ADDENDUM NO. 1

Bid #1506
ORANGE EDUCATION CENTER PORTABLES PHASE II
at
ORANGE EDUCATION CENTER

Project ID #3762, DSA #04-125366

ADDENDUM 1

FA2.02-2

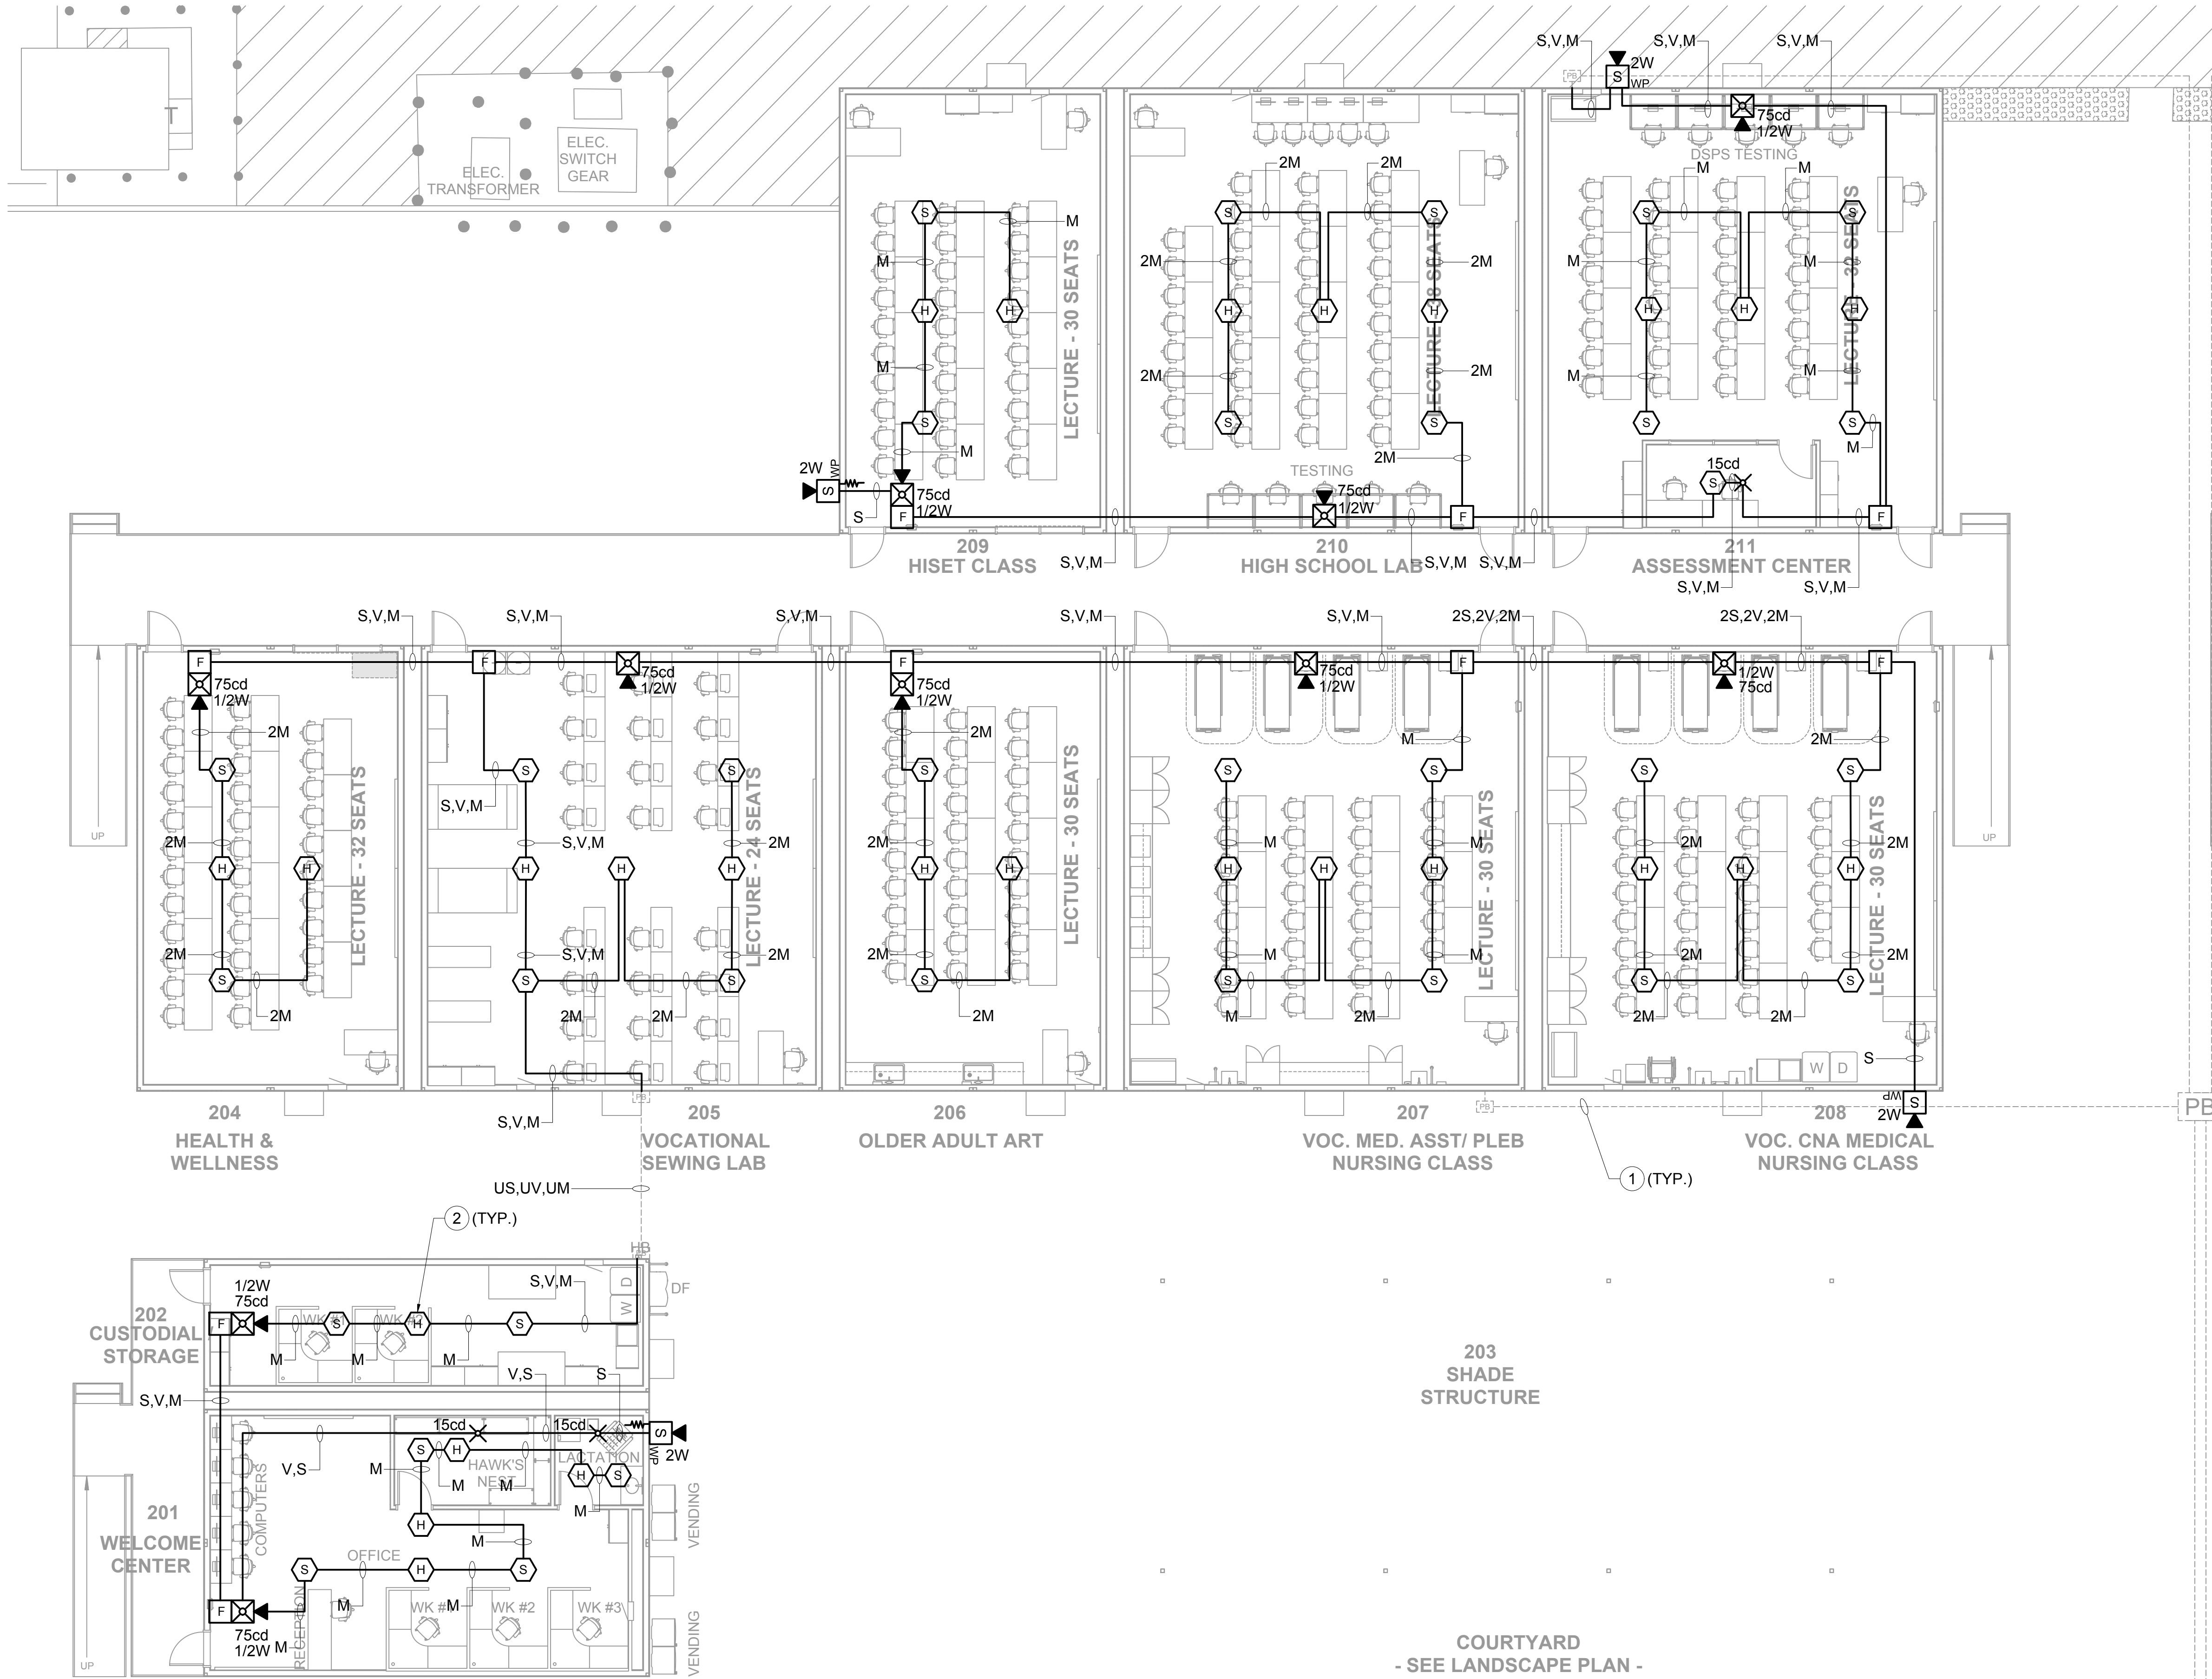
- 20. **FA2.01-2:**
 - A. Note added to heat detectors to note 3-0 ring will need to be installed by electrical contractor.
- 21. **FA2.02-2:**
 - A. Note added to heat detectors to note 3-0 ring will need to be installed by electrical contractor.
- 22. **FA2.03-2:**
 - A. Note added to heat detectors to note 3-0 ring will need to be installed by electrical contractor.

A1.00

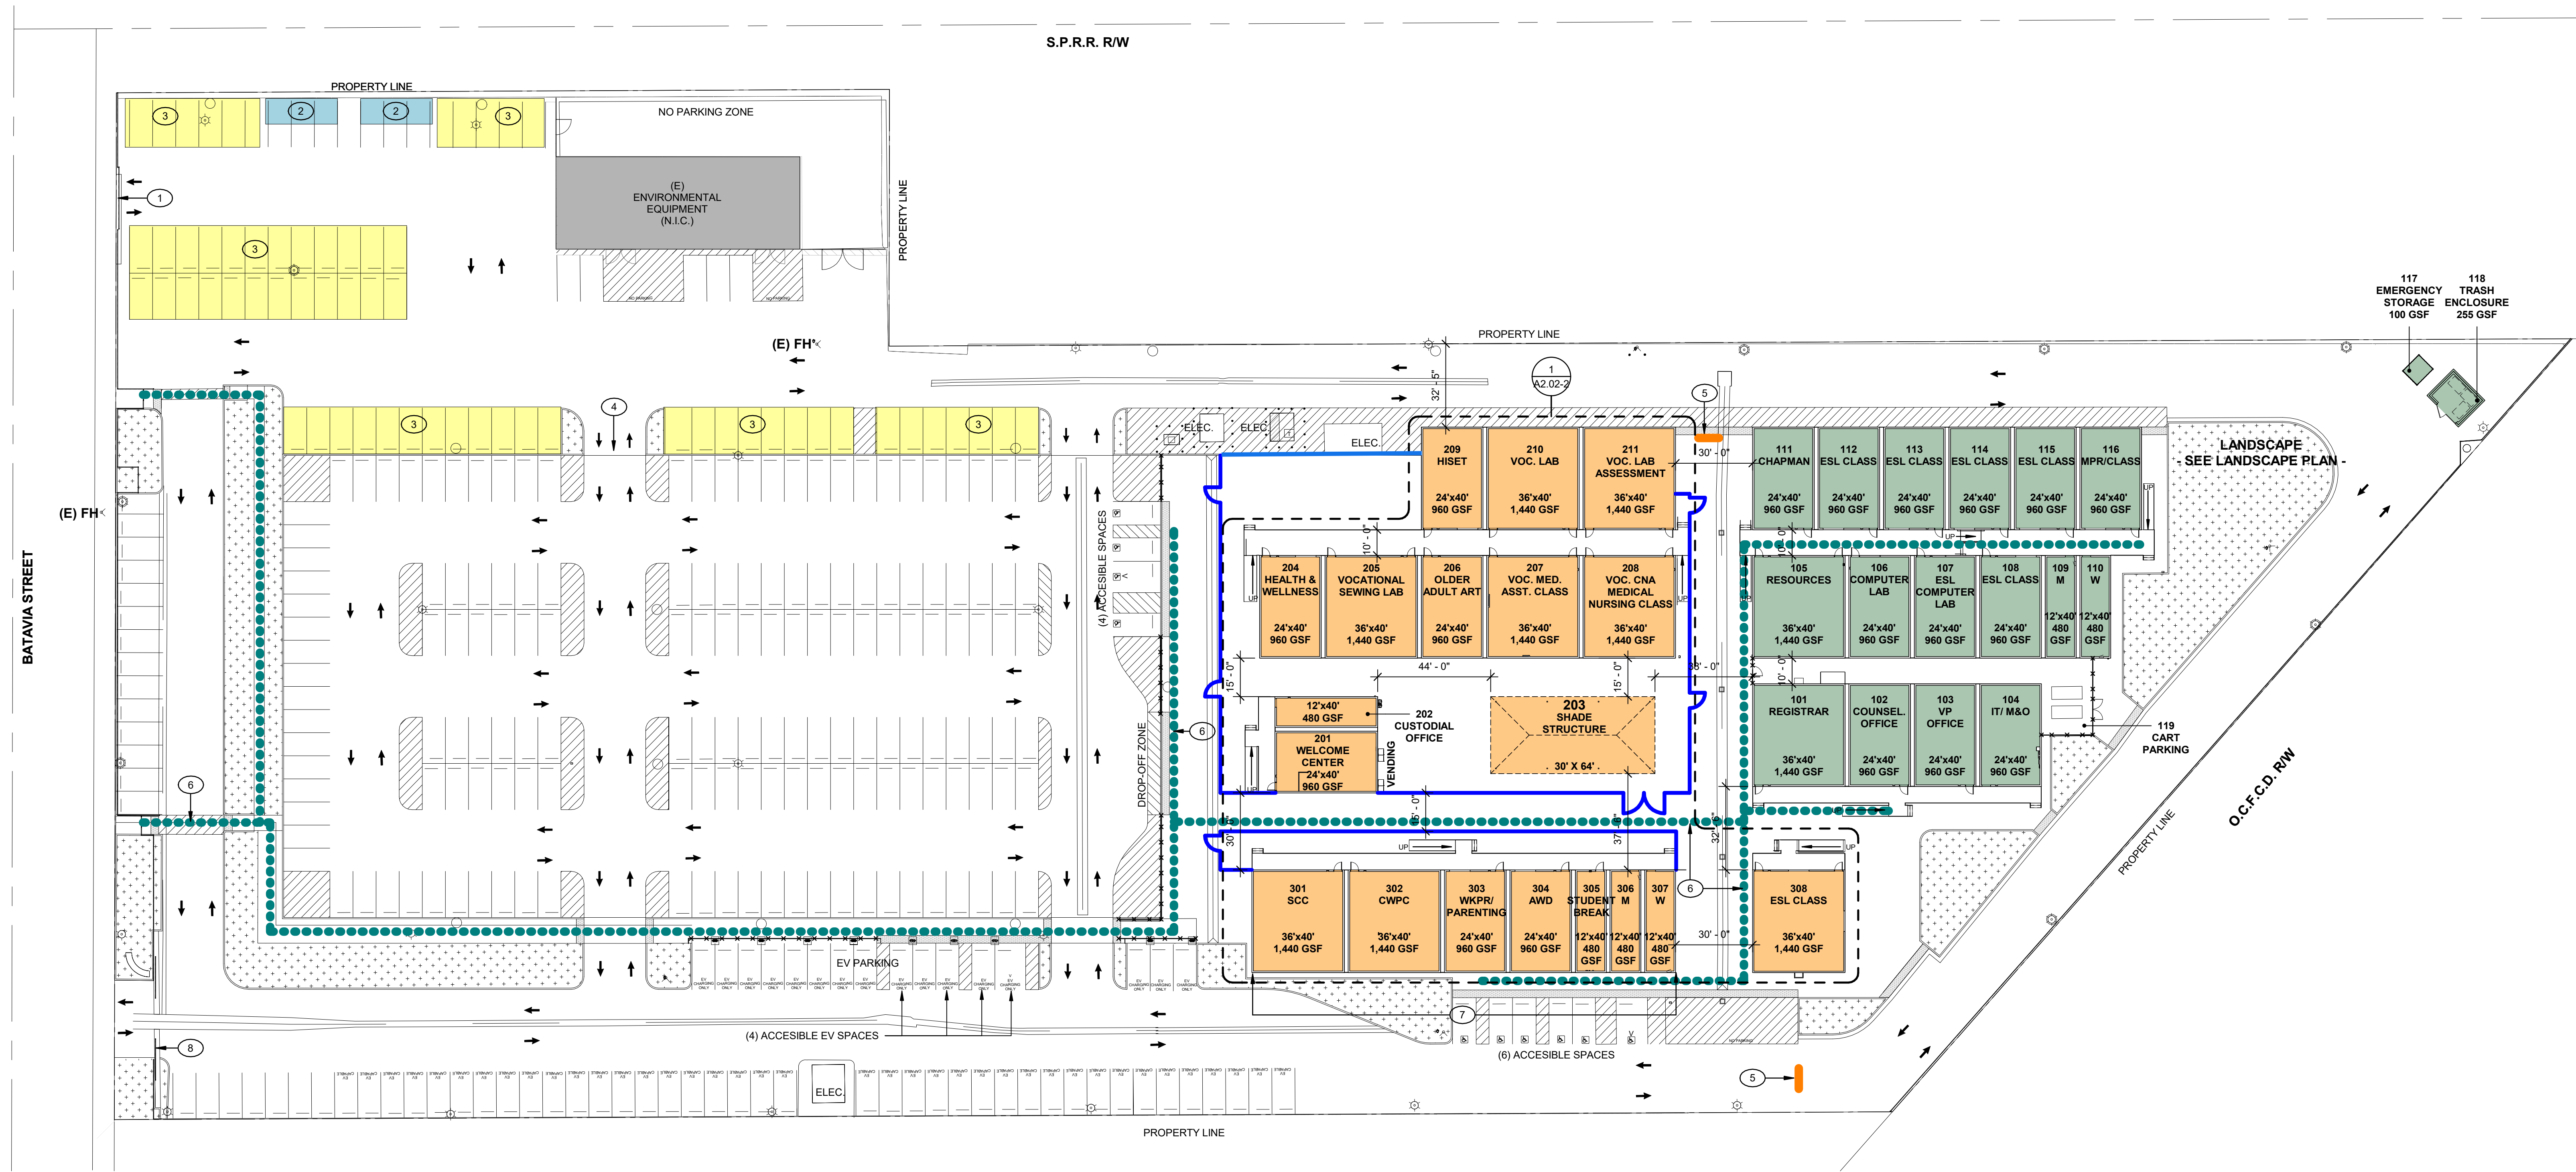
- 34. **A1.00:**
 - A. Added Construction Fencing & Staging Area. The Bidder shall include in the Base Bid all labor, materials, equipment, delivery, installation, maintenance, relocation, and removal necessary to provide an additional 500 linear feet (LF) of construction fencing for the Owner's use.
